S E R V I C E N O T E

**EPM442A Power Meter
(Product Number E4419A)**

In Line Fuse Holder Clips Defect.

Duplicate Service Notes: E4418A-02A

Figure 4

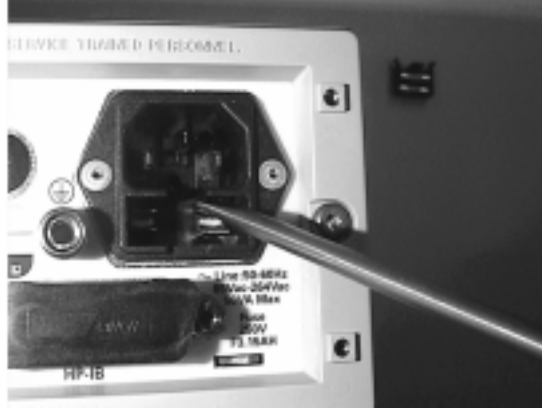
- 5) If there is any evidence of arcing then proceed to step 8.
- 6) If there is no evidence of arcing then bend the fuse clip into the correct position (i.e. level with the left hand clip) using a Flat Blade screw as shown in figure 4. Proceed to step 7.

Figure 5

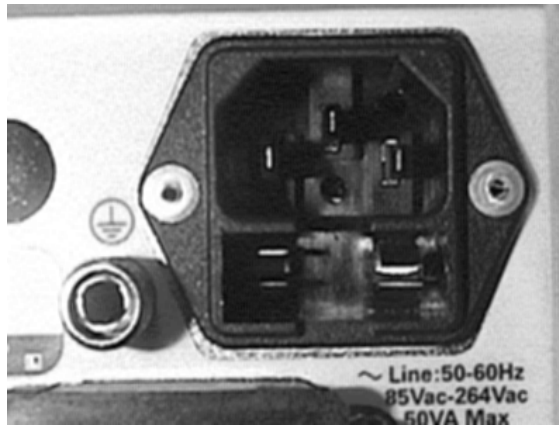
- 7) Ensure the fuse holder clip has not been bent too far (as per Figure 5).

If it is bent too far bend it to the correct position as per step 6 Proceed to step 9.
